ADDENDUM NO. 2

Replace Boilers and Controls
Farmington Correctional Center
Farmington, MO
PROJECT NO.: C2006-01

Bidders are hereby informed that the construction Plans and/or Specifications are modified as follows:

101 EXISTING MCC-MCA ELEVATION
 E-501 SCALE: 1" = 1'-0"

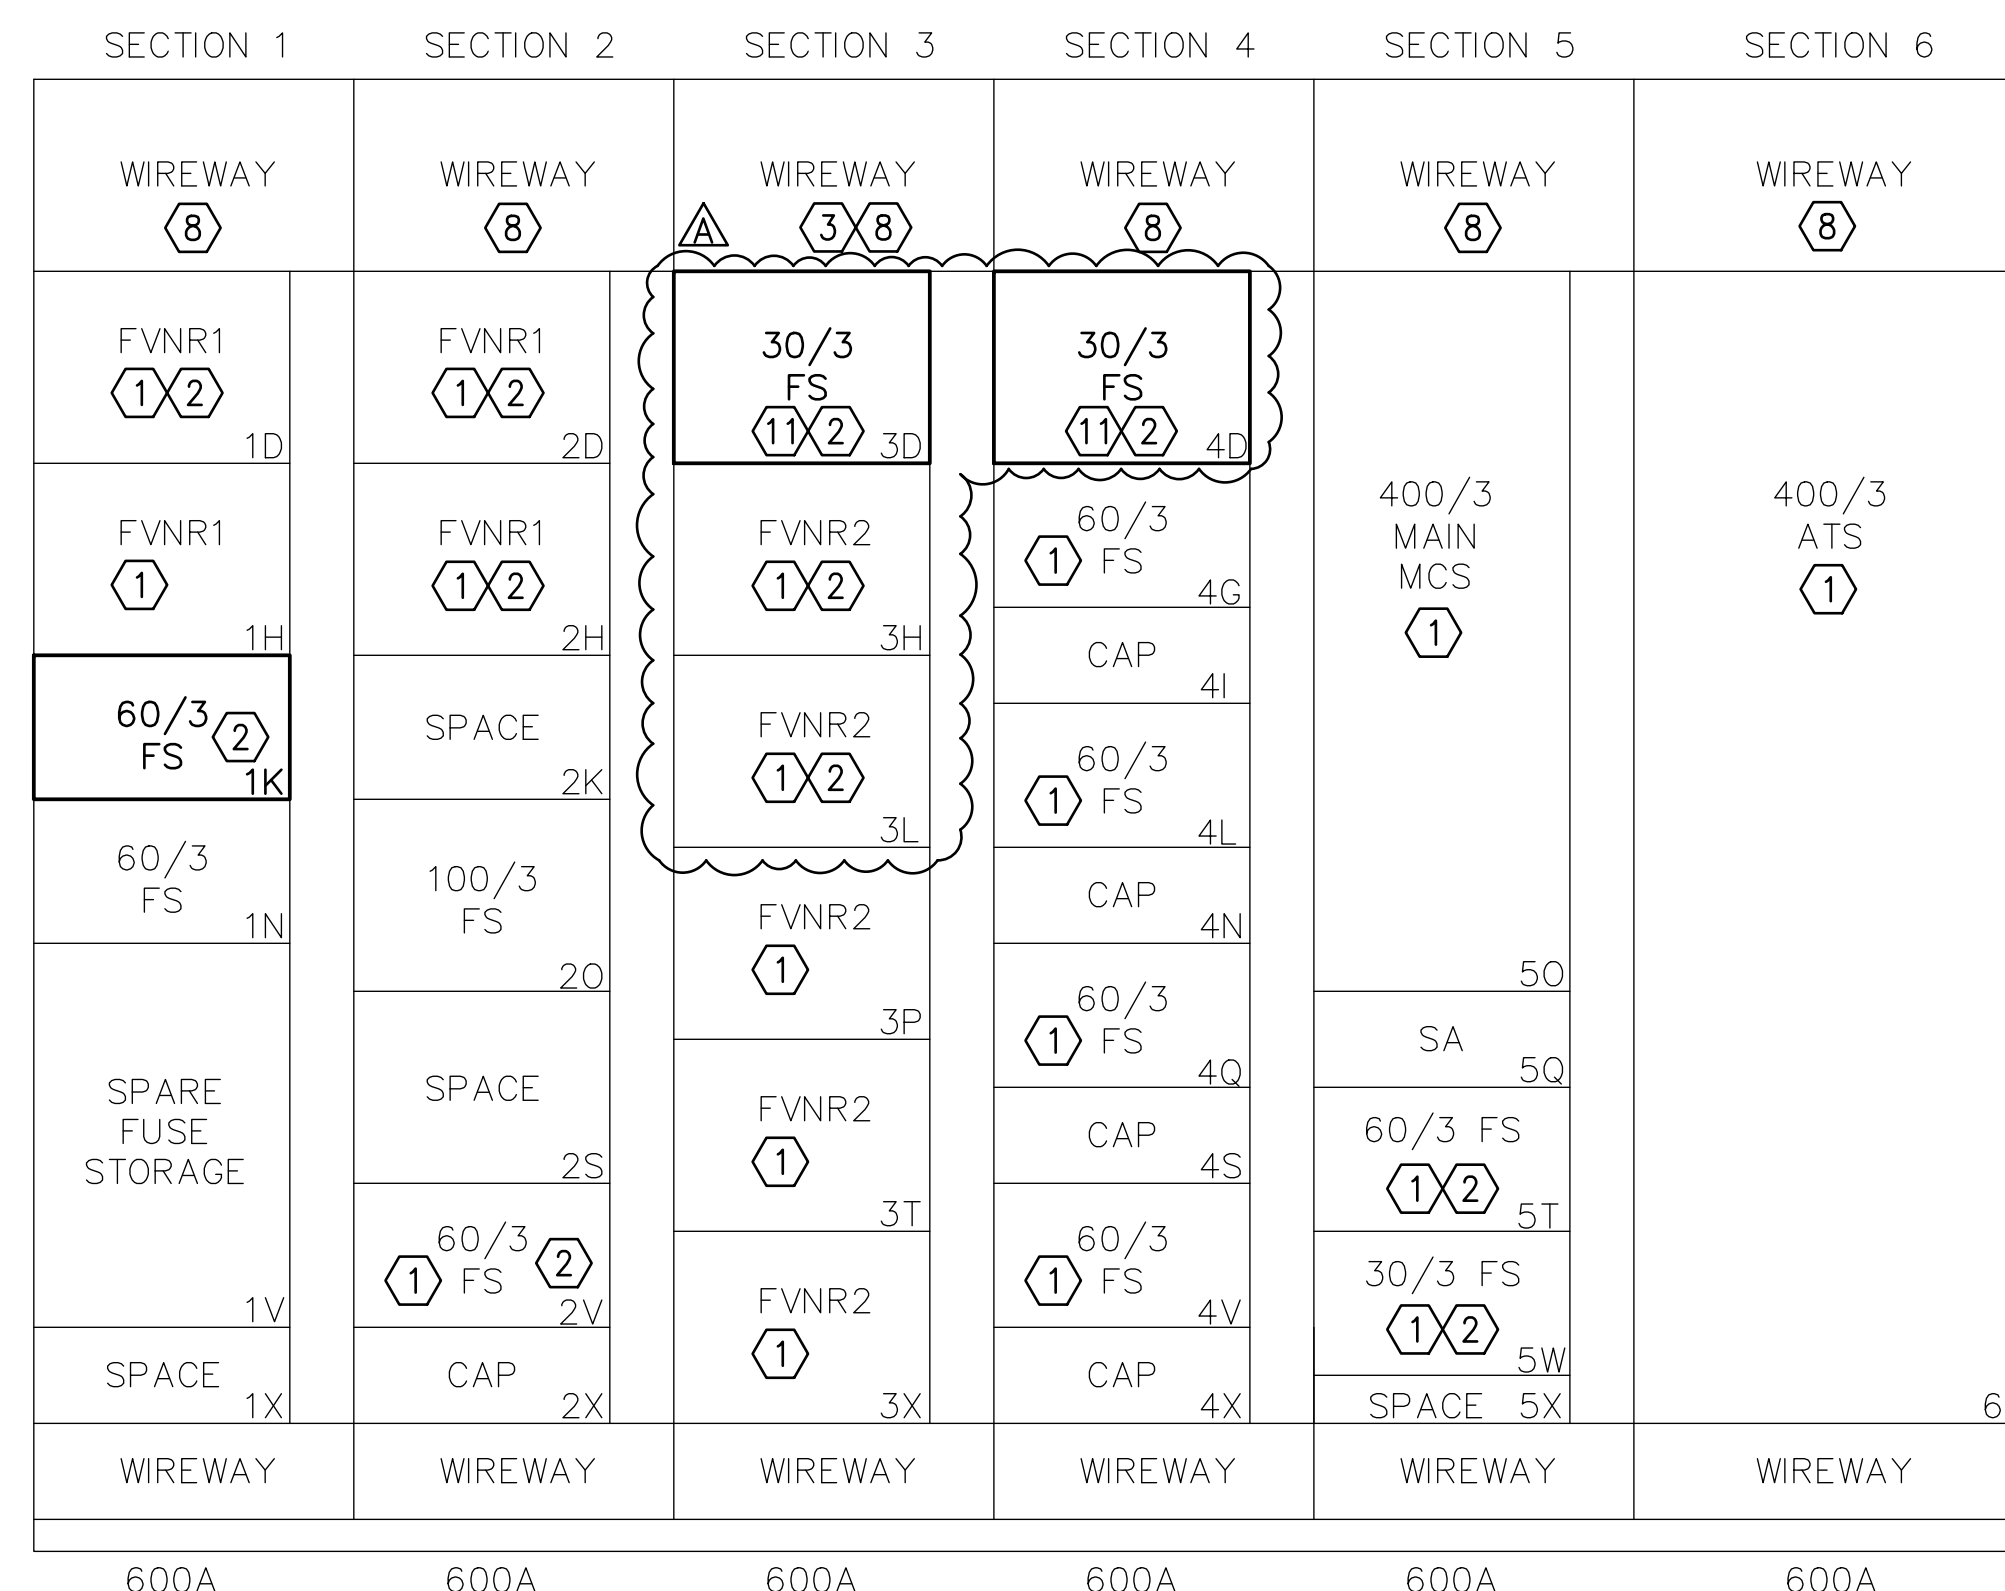
1. Volume 2 - Drawing E-501 – Schedules, Details & Elevations
 - a. **REVISE** per attached Revision A, dated 8/22/2023.
2. Volume 2 - Drawing E-601 – One-Line Diagram – North
 - a. **REVISE** per attached Revision A, dated 8/22/2023.
3. Volume 2 - Drawing E-602 – Motor Wiring Schematic
 - a. **ADD** new General Note E as follows:
 - E. CONFIGURE VFD AS REQD FOR OPERATION ON 480V-3Φ-3W GROUNDED BΦ POWER SYSTEM PER SPECIFICATION SECTION 230515.
